SUBJECT: AMENDMENT NO. 126 TO FACILITY OPERATING LICENSE NO. DPR-50

THREE MILE ISLAND NUCLEAR STATION, UNIT NO. 1

AMENDMENT TO FACILITY OPERATING LICENSE

Amendment No. 126
License No. DPR-50

Figure 2.1-2

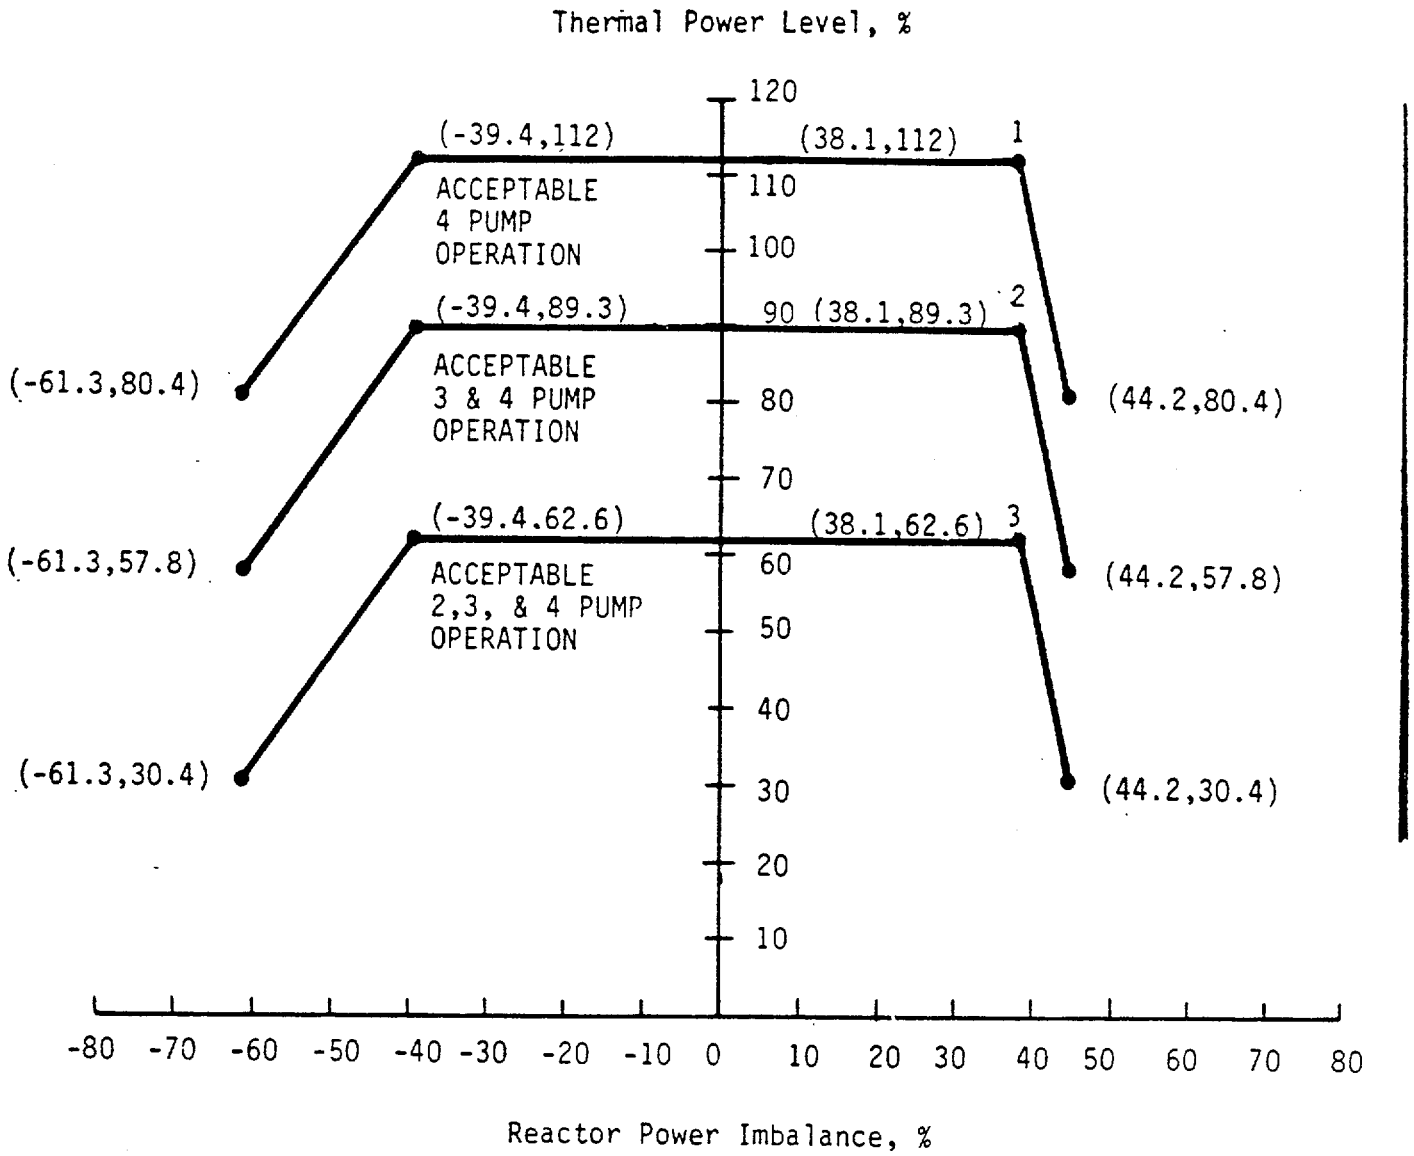
4. Figure 2.1-2, Core Protection Safety Limits

The curves on the figure present the power-imbalance envelopes, for various pump operation, that meet the centerline fuel melt and DNBR criteria. These curves are derived from Figure 2.3-2 by removal of instrumentation error and calculational uncertainties in flux/flow determinations. The curves reflect widening of the power-imbalance envelopes as well as increased Reactor Protection System instrument errors. Figure 2.1-2 is acceptable since it reflects Cycle 6 analysis by being derived from Figure 2.3-2.

Figure 2.1-3

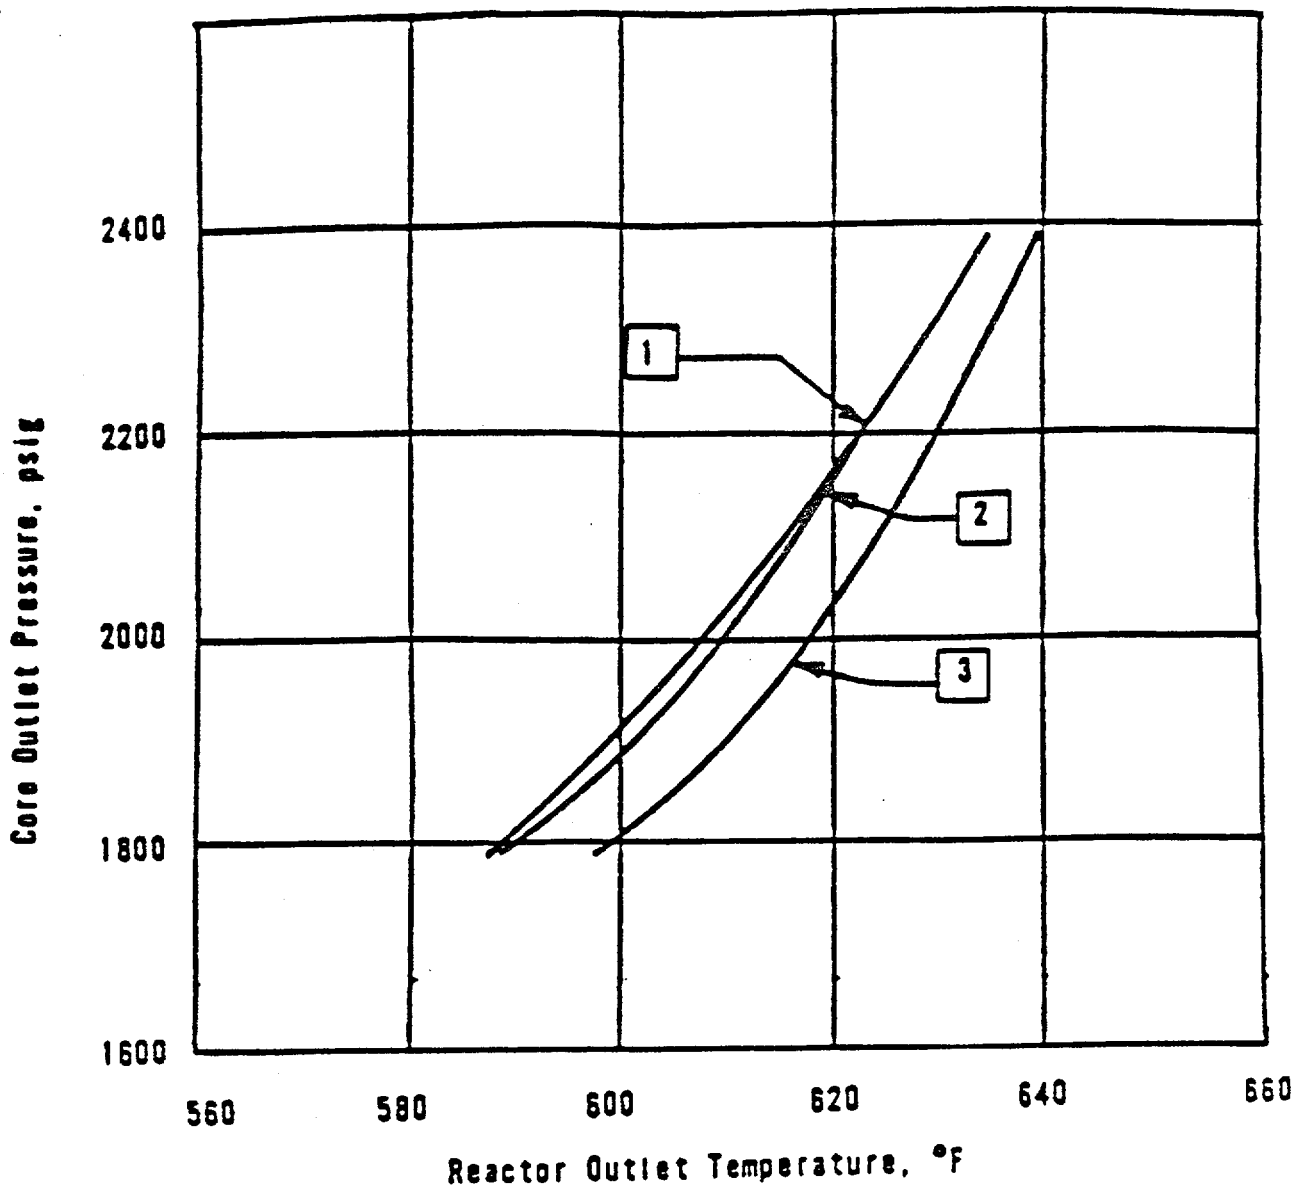
5. Figure 2.1-3, Core Protection Safety Bases

The curves on this figure have been revised to reflect small changes in the 2 and 3 pump allowable power levels. This change is acceptable since it reflects the revised Reactor Protection System instrument errors.

Figure 2.3-1

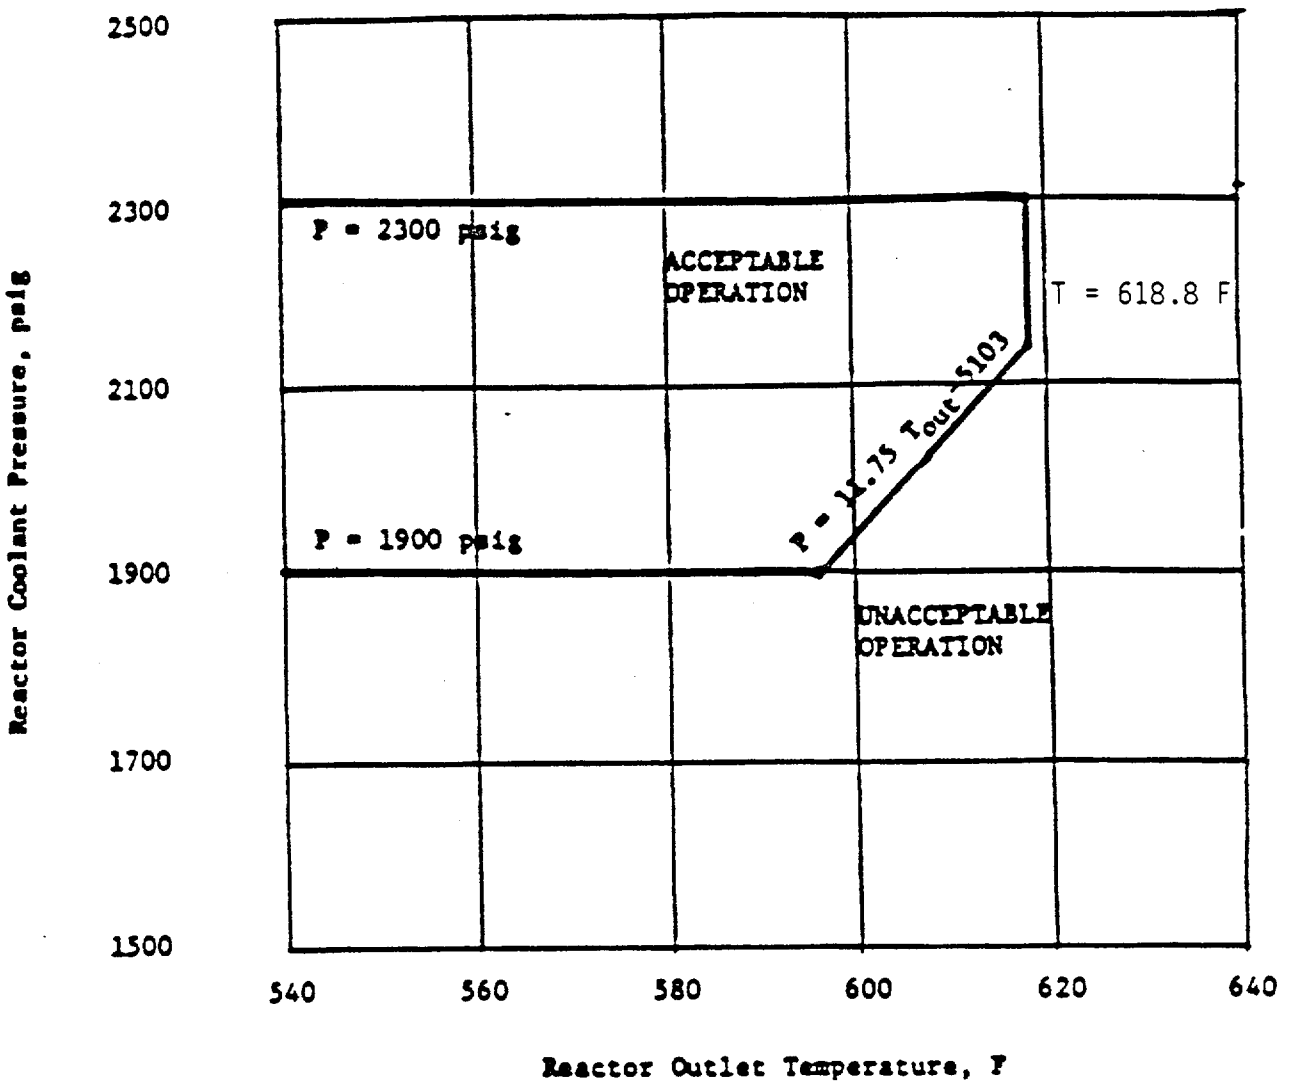
The high reactor coolant outlet temperature trip setting limit has been changed to 618.8°F from 619°F. This change is acceptable since it reflects the revised Reactor Protection System instrument error, which in this case is 1.2°F instead of the previous 1°F.

10. Figure 2.3-1, Reactor Protection System Maximum Allowable Setpoints

This figure has been revised to reflect the change in the high reactor coolant outlet temperature trip setting discussed in Item 8 above and is, therefore, acceptable.

Figure 2.3-2

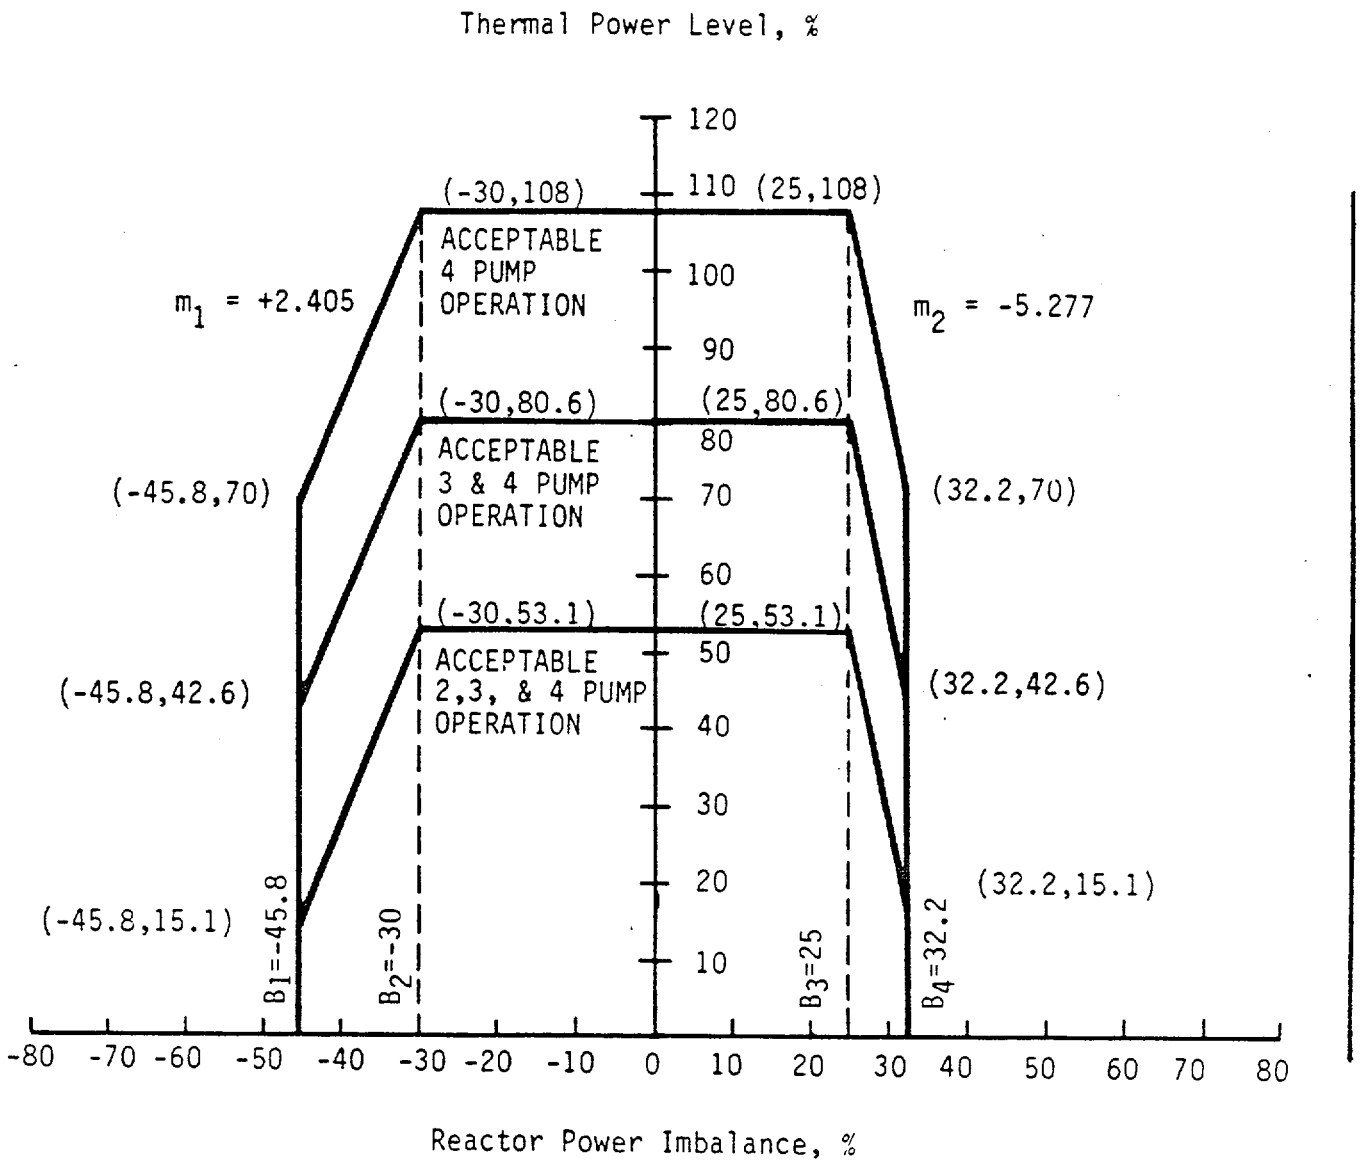
11. Figure 2.3-2, Reactor Protection System Maximum Allowable Setpoints for Power Imbalance

The figure is based on the Cycle 6 analyses discussed in previous sections of this Safety Evaluation. A flux/flow setpoint has been maintained to provide additional margin for the Cycle 6 pump coastdown analysis. Since the power/imbalance limits on the figure conservatively bound the thermal limits, they are acceptable.
